**Addendum No. 2 (Two)**  
**Request for Proposal RFP No. P24/10068**  
**Center Of Excellence in Health Professions – Audio Visual Systems**

**ADDENDUM 2:**

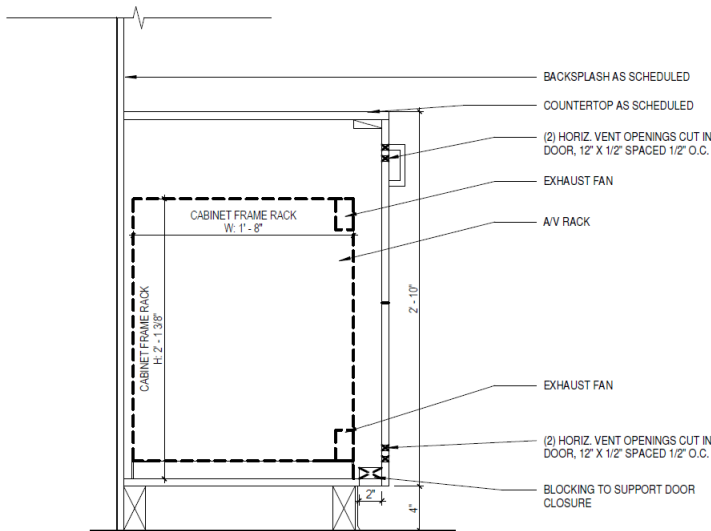
7. **Question:** Community Room

- a. on BOM, no specification for touch monitor on OFE lectern. Are these AV Contractor provided or customer provided/ofe?

**Answer:** These will be OFE
